schemata
workshop velmeir companies
cvs pharmacy west seattle

4722 fauntleroy way sw
seattle, wa 98126

early design guidance
DPD project # 3015817 + 3019746

25 June 2015 EDG meeting 2

composite diagram of EDG #1 options 1, 2, and 3

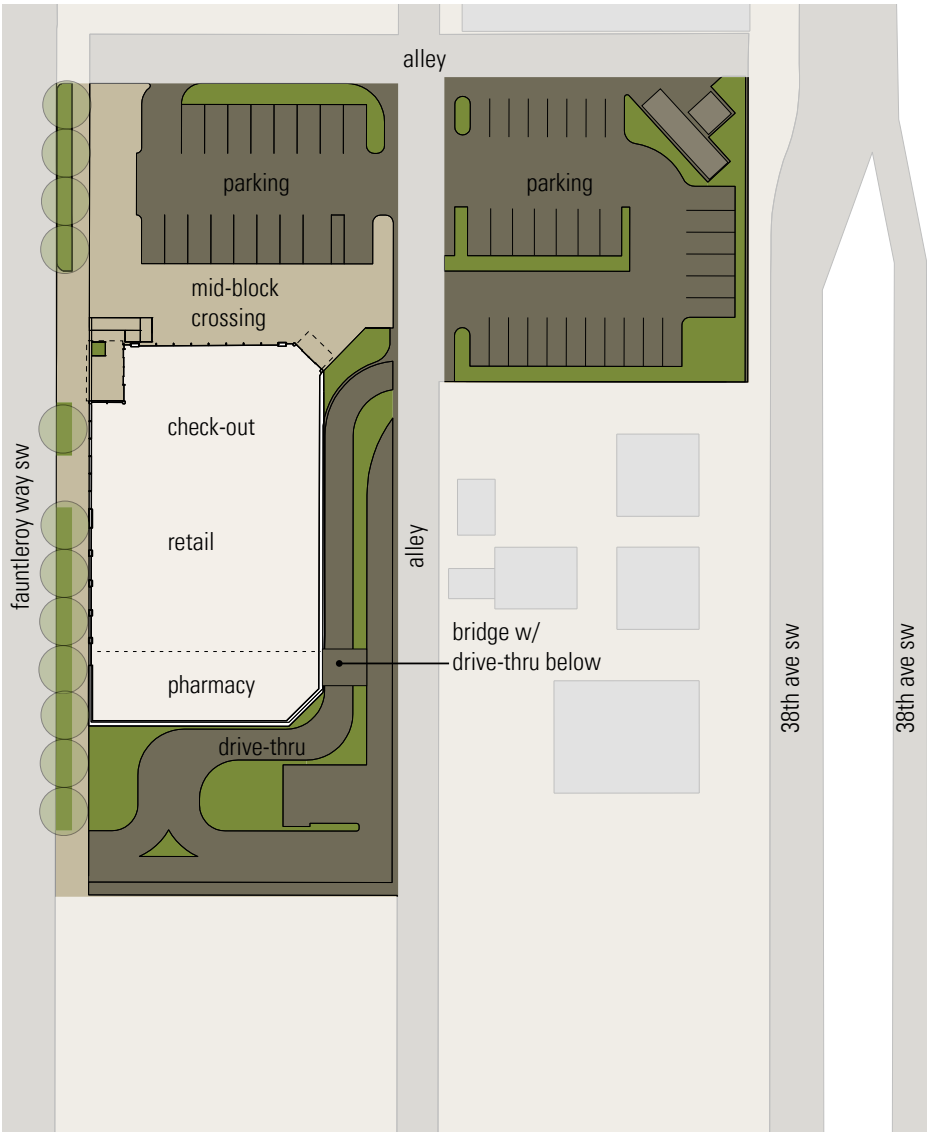
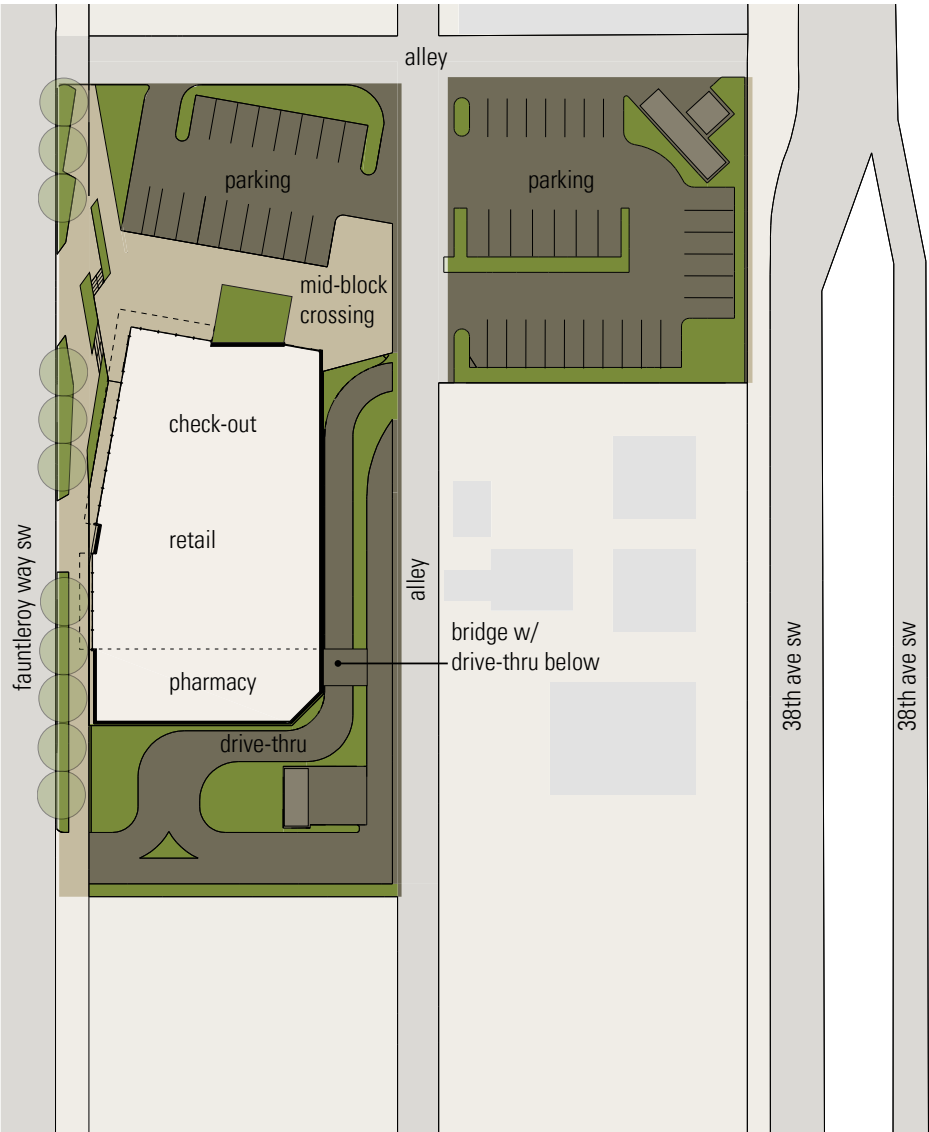
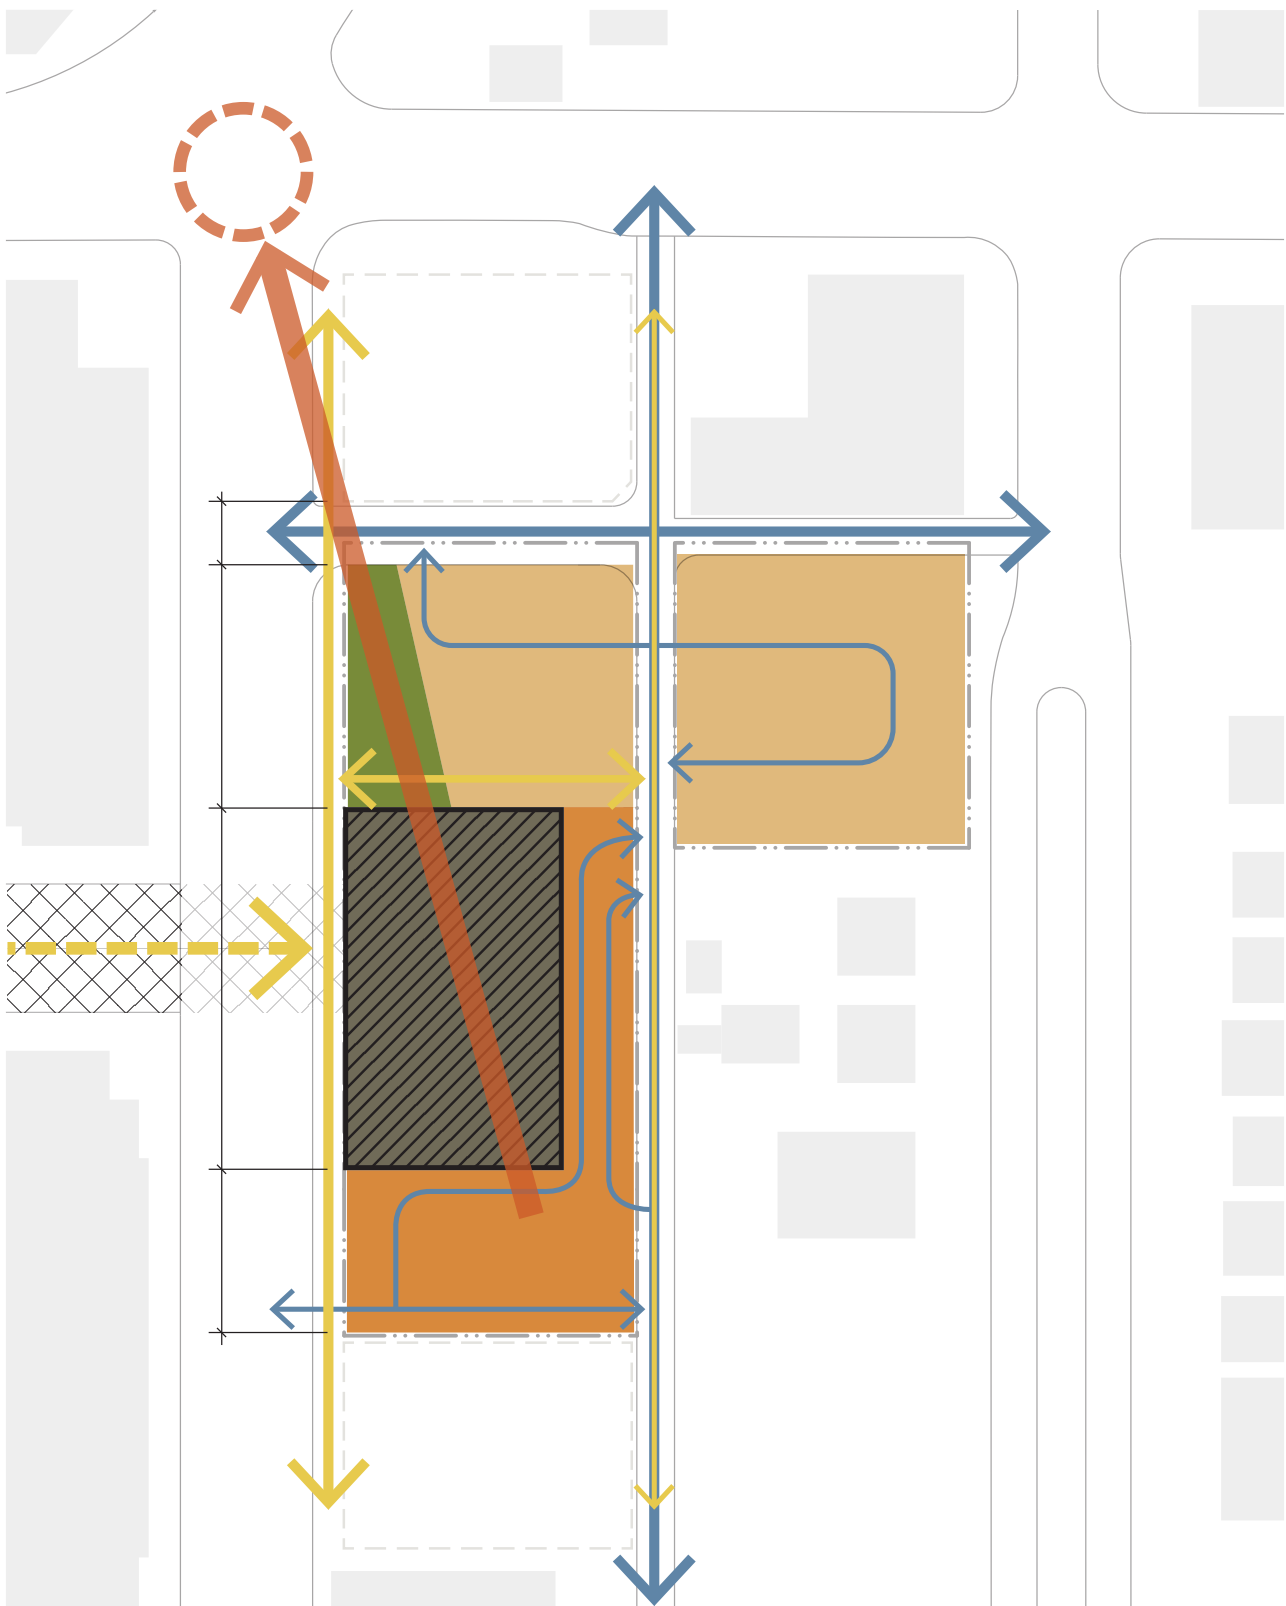
For the first EDG meeting, a variety of architectural expressions were explored; however, the site plans for the three options presented were similar with only minor variations between the options. Comments by the Board revealed shortcomings in this approach, and encouraged the design team to make it a priority to address them in the second EDG. The shortcomings of the first three options included:

1. A corner-oriented site design that related to the distant intersection of Alaska and Fauntleroy, instead of relating directly to Fauntleroy.
2. Treating the building as an object in the landscape, giving the project a suburban character.
3. Insufficiently screening the automobile-related uses.
4. Lack of defined (and safe) pedestrian circulation spaces.
5. Insufficient street presence and not enough support for an active pedestrian environment.
6. An ambiguous definition between the building design and the mid-block connector across Fauntleroy.

section 4 | priorities & board recommendation responses

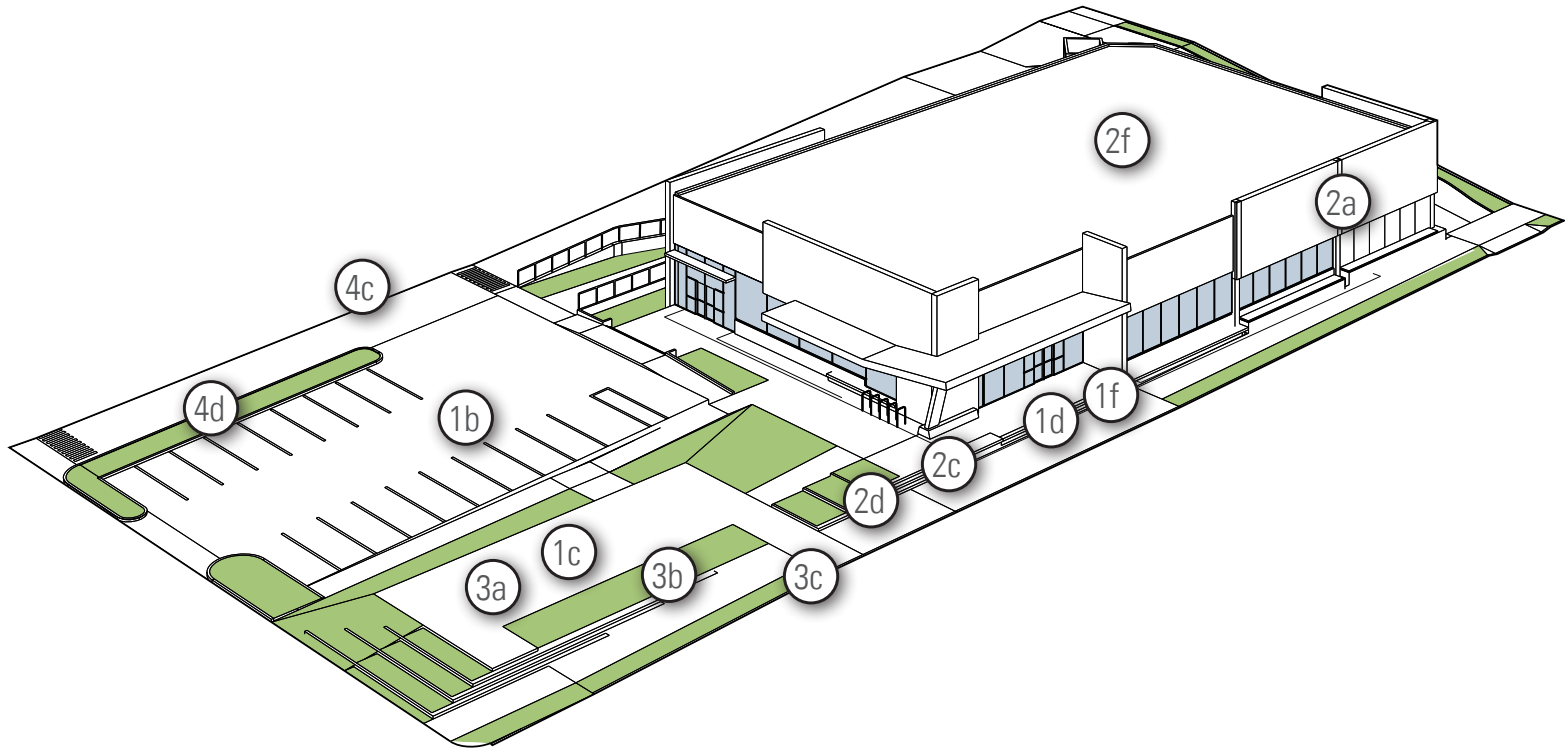
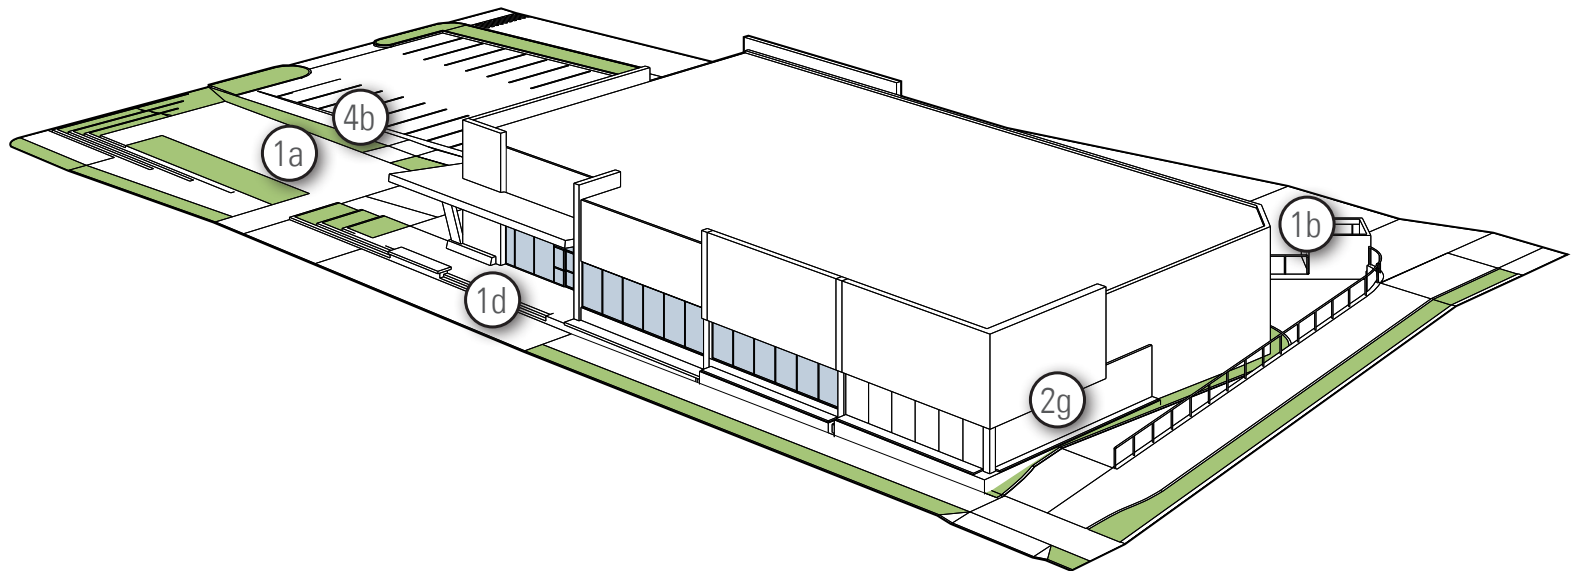
| | | COMMENT | GUIDANCE | PROPOSAL |
|-------------------------|----|---|--|---|
| SITE & CONTEXT RESPONSE | 1a | demonstrate pedestrian-oriented design | create a “jewel box in a park-like setting” | a pocket park is proposed |
| | 1b | prioritizes vehicular infrastructure, creating voids in the public realm and street wall | smaller, less visible, footprint to vehicles . . . greater emphasis on the pedestrian | the north west parking lot has been re-oriented, screened, and moved east; the area for the drive-through has been reduced |
| | 1c | (NC3-85) anticipates a more dense use | promote and capture the activity [of] a more dense development | the pocket park can host and promote a wide range of activities and number of users |
| | 1d | appears to take on a corner lot orientation | respond to its mid-block location . . . strengthen relationship . . . to Fauntleroy | the building has been moved south, and the entry faces Fauntleroy |
| | 1f | the relationship [to the mid-block crossing] would most likely be only visual | building modulation . . . or a focal point to align with the sightline | the building entry aligns with the mid-block crossing |
| MASSING & COMPOSITION | 2a | supported the proposed massing in Option 2 | explore modulation that reinforces the design and referenced . . . California Ave | the modulation has greater expression |
| | 2c | the facade on Fauntleroy does not engage the pedestrian | further . . . modulation & façade articulation . . . visually reinforces the streetwall | the entry set-back and canopy, as well as its stairs and their extension into the pocket park visually and spatially reinforce the streetwall |
| | 2d | the retail entry is above the sidewalk grade | rethink the grade changes . . . to improve accessibility on site | the stairs to the entry lends greater street presence, reinforcing the board guidance |
| | 2f | the roof plane will be highly visible | special attention [should be paid to the] 5th façade | the roof contains patterning reinforcing the landscape design |
| | 2g | south end of the building [is] highly visible | [reduce] the visual impact and enhancing the pedestrian environment | grade, planting, and material articulation screen and enhance the south wall |
| OPEN SPACE & AMENITIES | 3a | | strengthen and clarify the overall building-open space relationship | a larger open space is provided at the north of the site, a smaller to the south |
| | 3b | | consider larger planting areas to give the site a park-like character | large planting areas are provided |
| | 3c | | explore opportunities for integrating the transit stop into the design | the stop will be integrated into the design |
| VEHICULAR ACCESS | 4a | [drive-thru] provide . . . safety . . . revise the design to remove this area if possible | [provide] elevations, sections, and perspectives of the alley | the drawings are provided in following pages |
| | 4b | concern [with the] . . . parking lot[s], drive-through, and service areas from Fauntleroy | explore alternatives for a site plan that reduces the amount of void space, visually reinforces the street wall, and establishes a pedestrian-oriented streetscape | parking has been re-oriented and screened, drive through area made smaller, and planted area more robust |
| | 4c | more detail regarding the parking areas . . including screening and safe pedestrian pathways through parking lots | | the screening of the parking is larger and denser, clear pedestrian routes will be provided |
| | 4d | the alley . . . at the north end of the site | adding pedestrian-oriented features . . . to improve the safety and functionality | a landscaped, pedestrian way is provided on the west edge of the alley |

entry and modulation

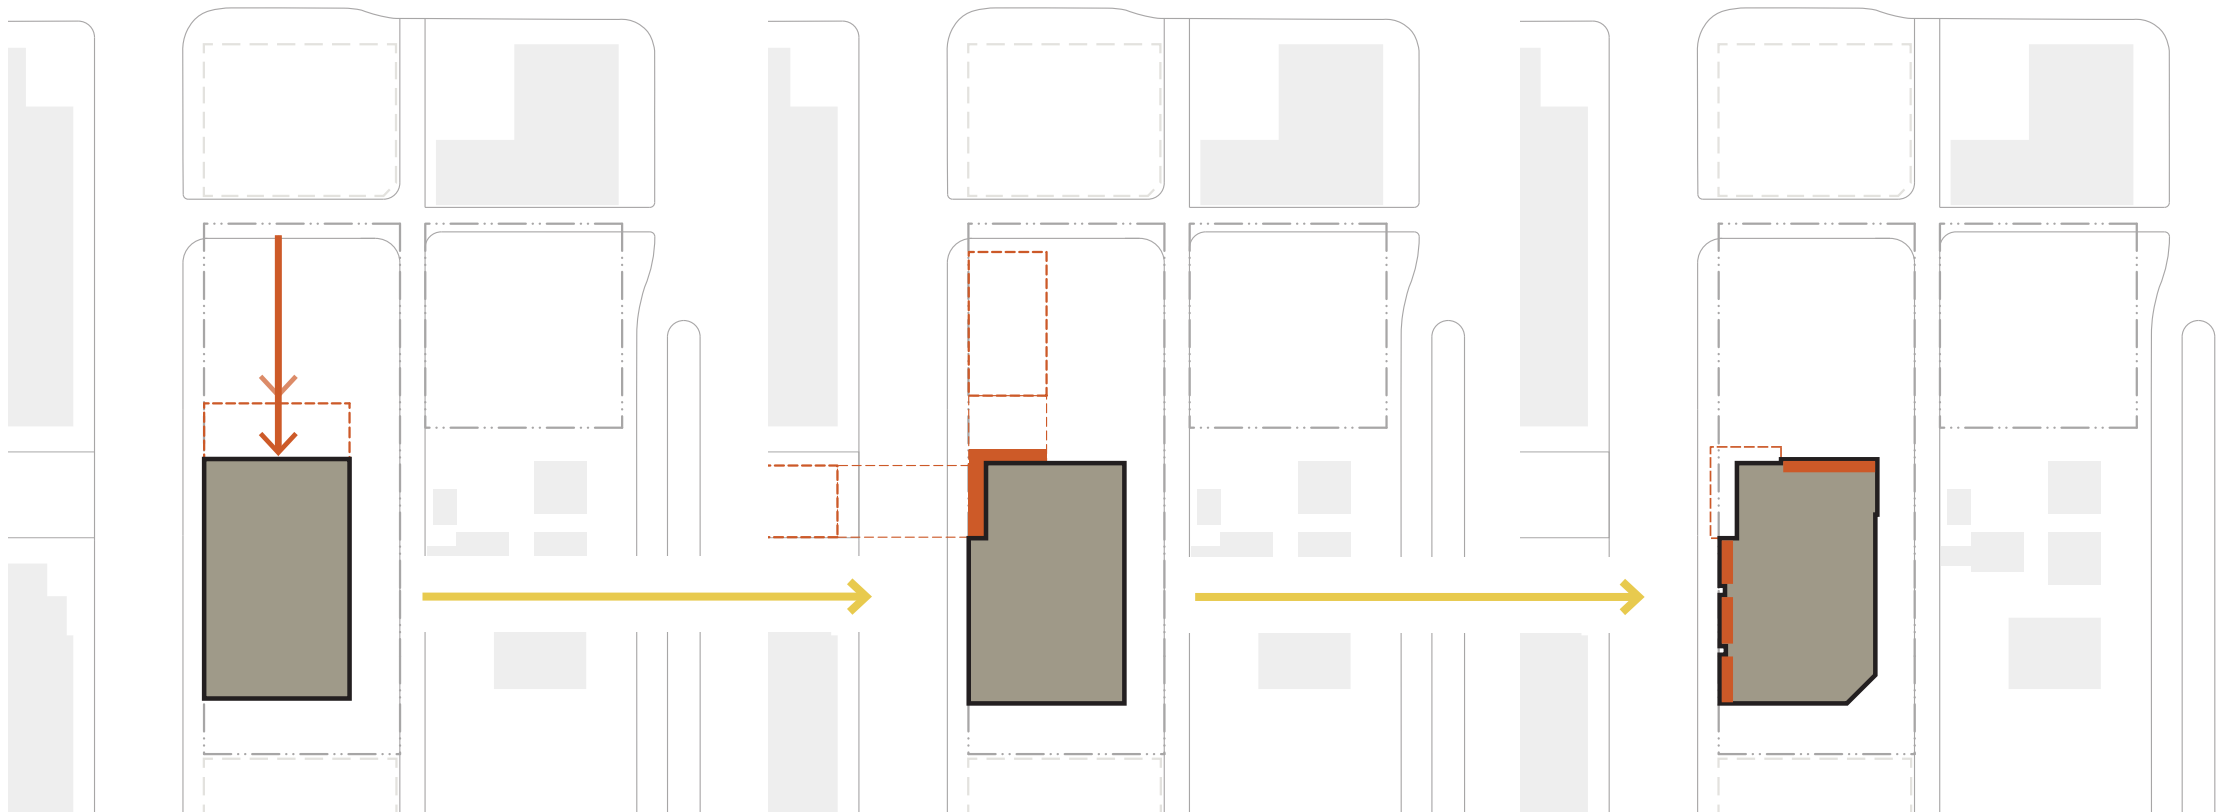
priorities & recommendations: 1d, 1f, 2a, & 2c

- The building moves to the south, freeing up the northern part of the site for the pocket park.
- The entry is relocated from the corner and aligned visually with the mid-block crossing; the entry area is recessed
- The dimension of the entry-recess becomes the dimension for the modulation of the north and west facades
- A canopy is placed in the entry recess, and extended north towards the pocket park, to strengthen the entrance’s relationship to both Fauntleroy and the pocket park

street presence and pedestrian circulation

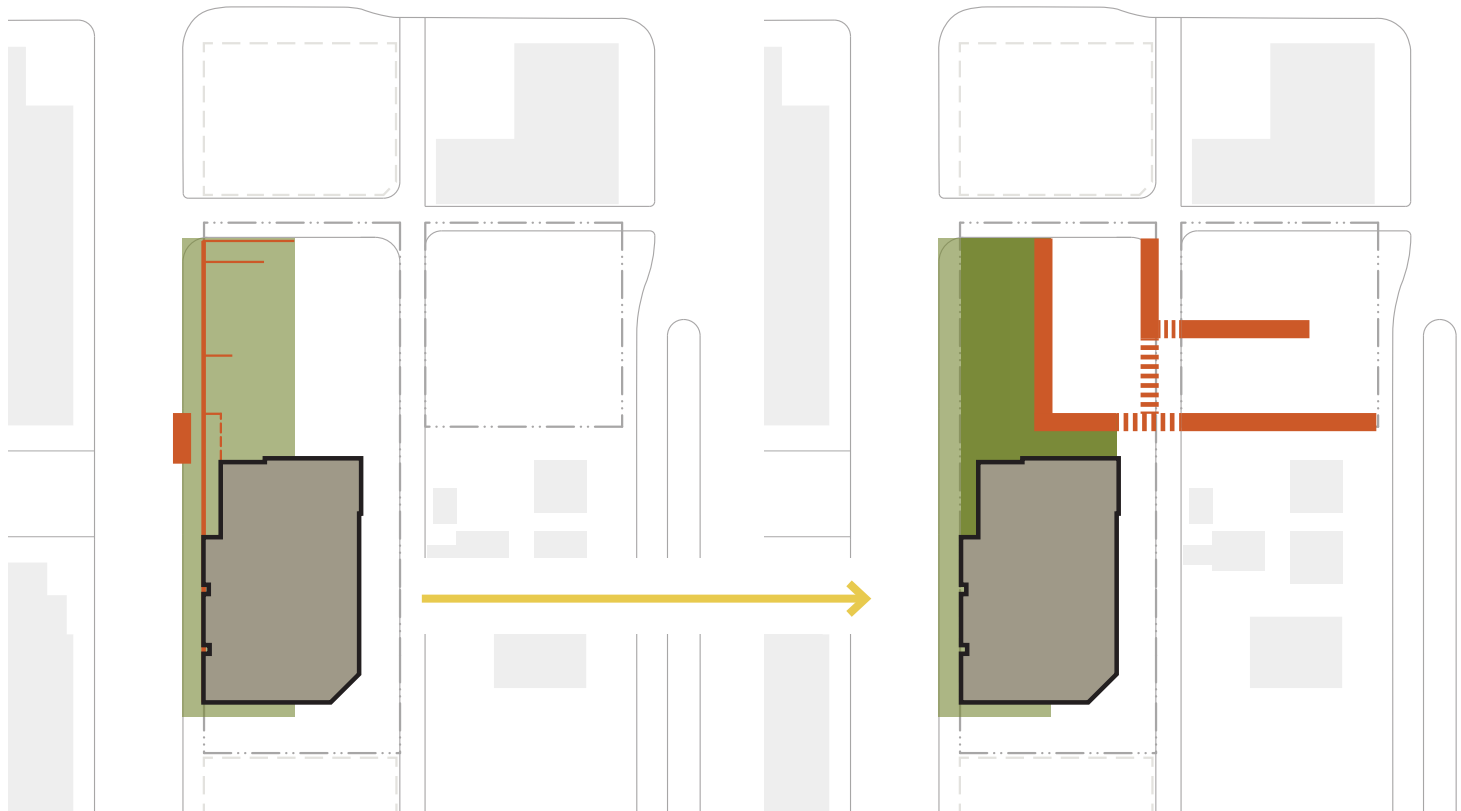
priorities & recommendations: 2d, 3b, 3c, 4b, 4c, & 4d

- Steps, benches, and planters align with the Fauntleroy elevation and extend the building wall to the north of the site
- Bus patrons will have use of the benches as they wait for the bus
- Pathways along the alley, the pocket park, and across the parking area guide patrons safely to the building
